TOWN OF PALM BEACH

PZ&B Staff Combination Memorandum: Landmarks Preservation Commission and Town Council

SUBJECT: ZON-24-0055 (COA-24-0022) 120-132 N COUNTY RD—
Palm Beach Synagogue

ZON-24-0055 (COA-24-0022) 120-132 N COUNTY RD—PALM BEACH SYNAGOGUE (COMBO)—SPECIAL EXCEPTIONS WITH SITE PLAN REVIEW AND VARIANCES.

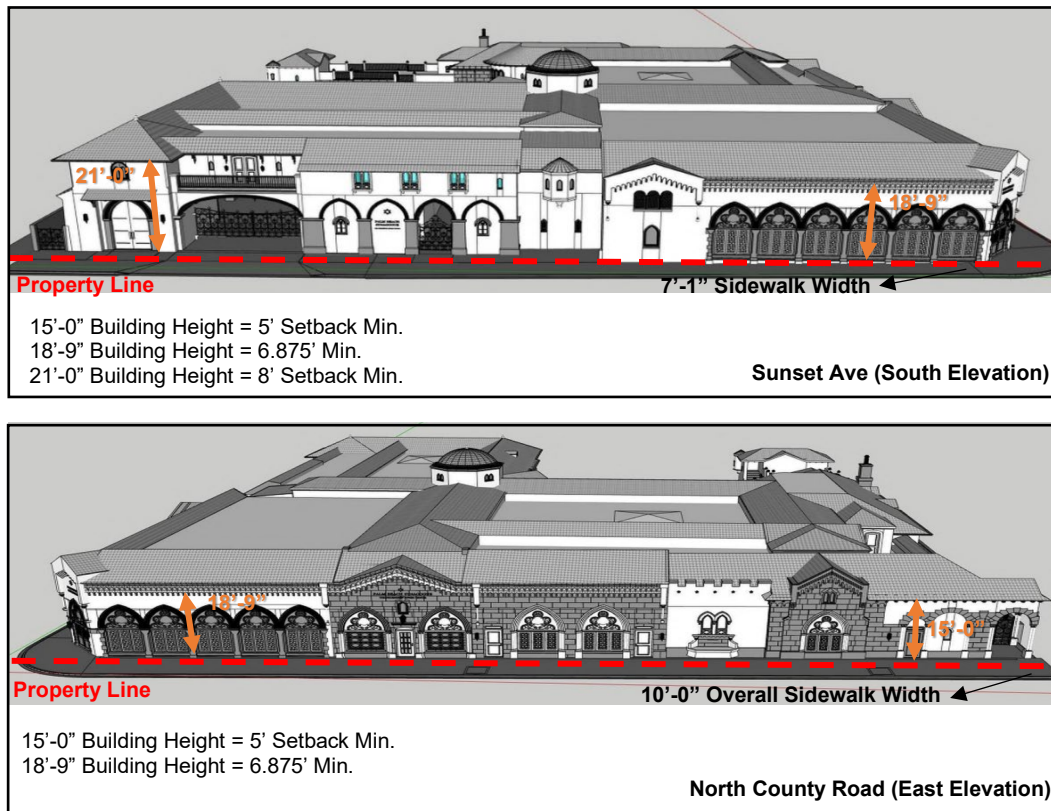
For buildings in excess of 15'-0" in height, all minimum yard requirements are increased by one foot for each two feet of building height, or portion thereof, exceeding 15'-0". The landmarked facades are the primary architecturally significant elements of the structures that are required to be retained. The existing synagogue is sited at the corner with a nonconforming front (south) setback

of 0.2' along Sunset Avenue. Along N County Rd, the existing synagogue is sited with a setback of 5'-0" which is non-conforming for the portion of the facade that exceeds a height of 15'-0". The variance applies to the existing portion of the building which is landmarked and the new additions. The required front yard setback along Sunset Ave ranges from 6.875' to 8' based on the portions of the building that exceed 15'-0" in height. Likewise, along N County Rd the required setback ranges from 5' to 6.875'.

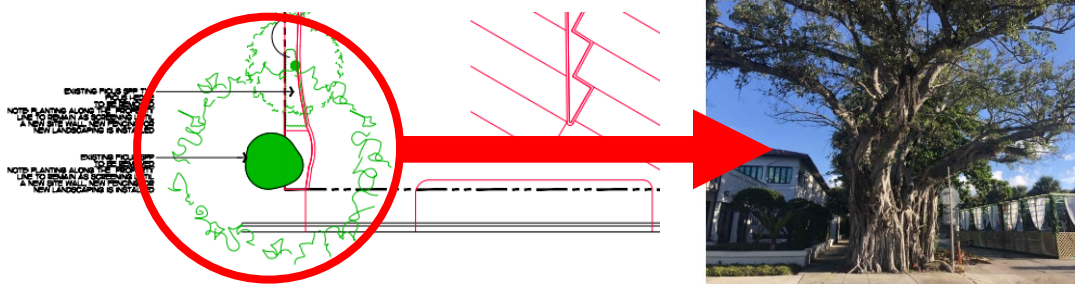
As it pertains to **Variance #3**, a variance to reduce the minimum required front yard landscape open space. The site has a nonconforming front yard open space, and due to the amount of demolition exceeding 50%, all nonconforming elements must be vested. The retention of the existing façade of the corner synagogue landmarked building, creates challenges in meeting the required 25%. The applicant has provided green planting areas in those portions of the new construction fronting the roadways—most notably along Sunset Ave. The proposal does improve the legal non-conformity of front yard open space along the Sunset Ave frontage from 10.6% to 18.05% and along the N County Road frontage from 0.5% to 15.2%. Staff has no objections to variance #3, but perhaps the applicant can further study areas that additional green space can be

incorporated on site, particularly at the northeast edge along the new construction where the social hall is located by setting back the building in selected areas.

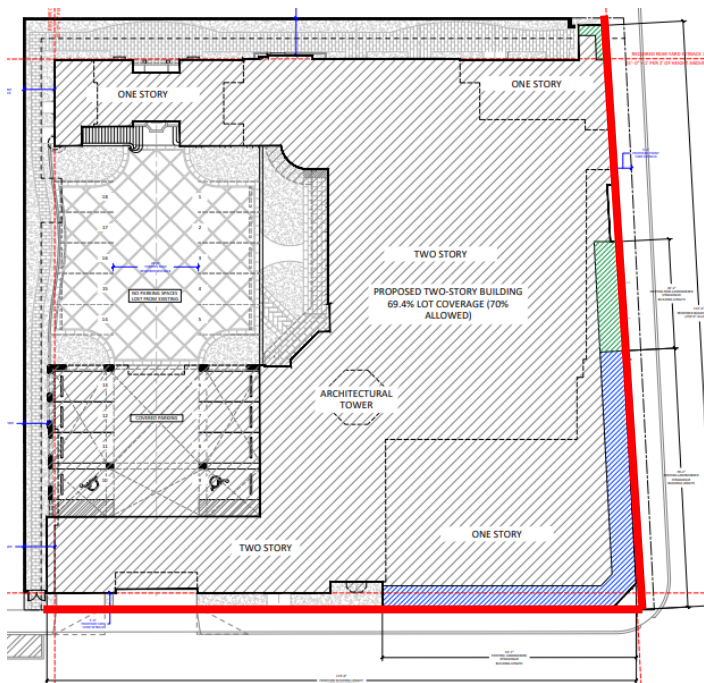
Variance #4 requests to exceed the maximum building length of 150'-0" maximum building length permitted; the request pertains to both sides (east and south) for the proposal of alterations and substantial additions of the corner building of N County Road and Sunset Ave. Along N County Road, the existing landmarked synagogue building has a 76'-2" long frontage plus an additional 32'-2" of non-landmarked portion of the synagogue. The other structures (formerly occupied by Chez Jean-Pierre Bistro) has a 63'-8" long frontage. This structure was approved to be demolished and is proposed to be replaced by an attached new addition. The variance along the east (N County Road) is to exceed the allowance by 22'-0" for a total frontage of 172'-0". This will extend the building nearly the entire linear length (174') of the eastern side of the site which will provide for a continuous urban edge, an optimal urban condition along commercial main streets. For visual reference the landmarked portion of the proposal is highlighted in blue in the diagram to the right.

building has a building length of 74'-7" and the new additions will extend this by 87'-5" to a total length of 173'-0" along the south (Sunset Ave) of the site. And while this portion of the variance is not a vesting of the existing conditions, it too, creates a continuous architectural edge to the site and will screen the parking in the rear of the site. This elevation will be broken in two portions, by a 7'-0" wide pedestrian accessway that has been provided at the westernmost portion of the site and at the ground floor by a 25'-0" wide covered vehicular driveway also located at the western portion of the site. Overall, the new construction along both elevations of the building have been exceedingly designed to vary in detail, style, features, and changes in plane.

Red Loading Zones are to the west of the site in front of 223 Sunset Avenue.

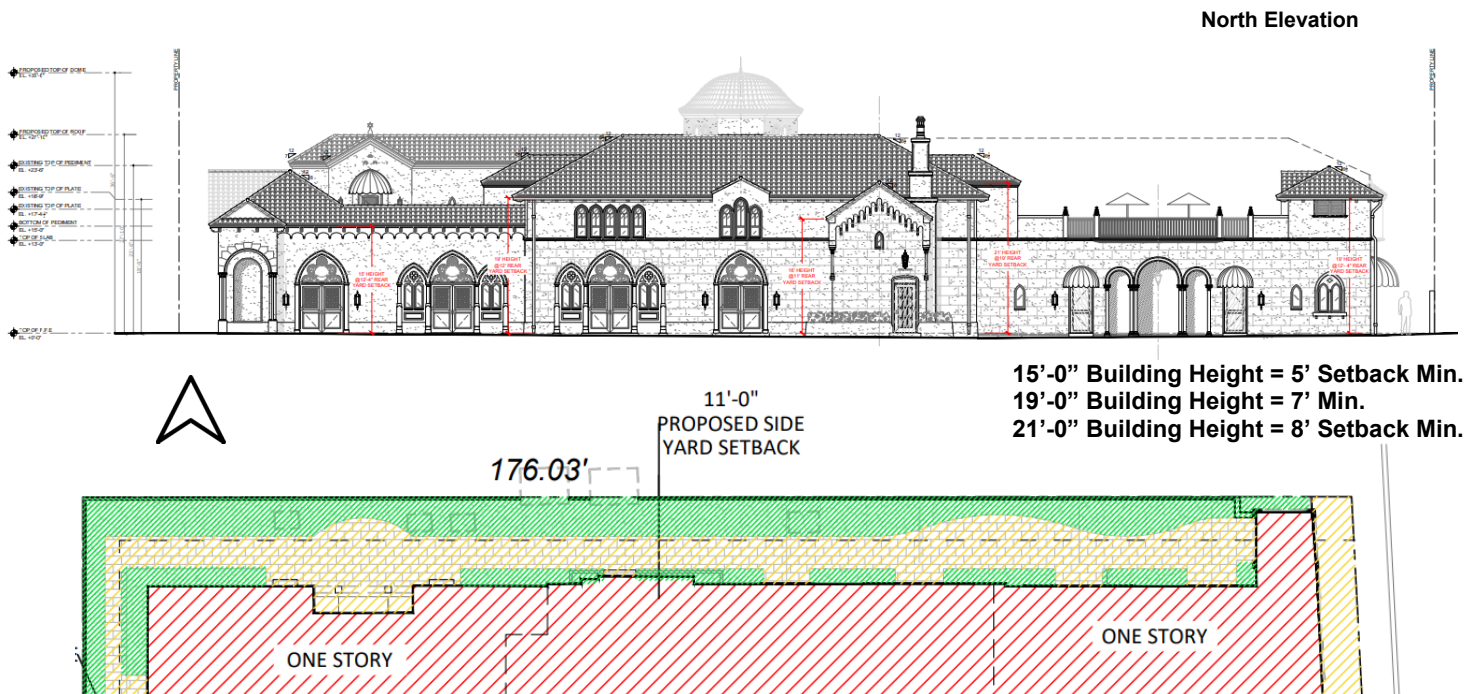
As it pertains to **Variance #7**, to not provide one required loading space for the religious facility, a request is made to grant this variance as the property has been in operation without one for nearly 100 years without a loading space. The code does require a minimum of two (2) dedicated loading berths (12' x 25') on-site for this sized program. If the site plan is approved, a non-dedicated on-site loading space can be provided for off-hours loading service that does not conflict with event operations and the proposed parking. Otherwise, the facility can utilize one of the existing

designated commercial loading spaces shown below located to the west of the subject property along Sunset Avenue.

West Elevation

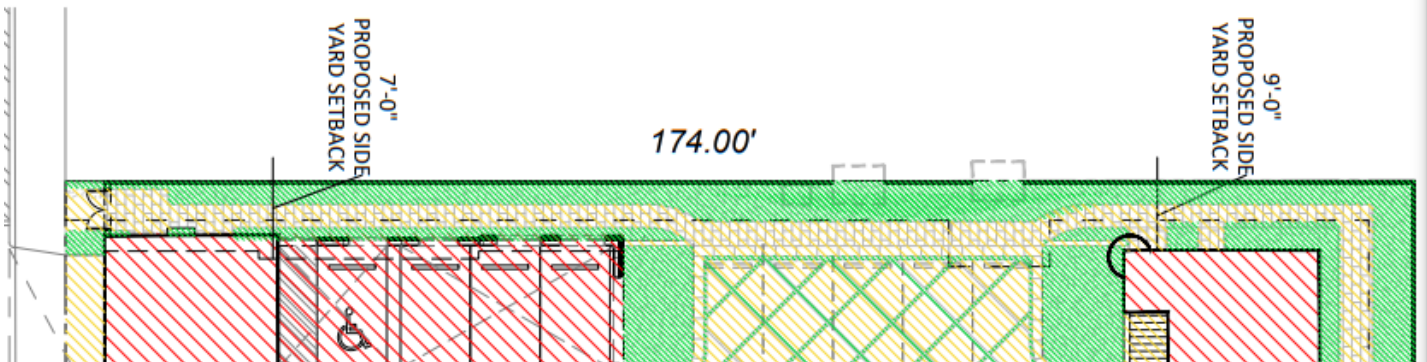
Variance #9 to reduce the minimum required rear yard (west) setback ranging from 7' in lieu of the required setback of 13'. The additions will provide a setback that ranges from 7' to 9'. An increased setback above 15 feet of height also applies to the rear setback areas, however, the

minimum setback here is 10 feet. Based on building heights, the required setback ranges from 12.166' to 13'.

15'-0" Building Height = 10' Setback Min.
 19'-0" Building Height = 12' Min.
 19'-4" Building Height = 12.166' Min.
 21'-0" Building Height = 13' Setback Min.
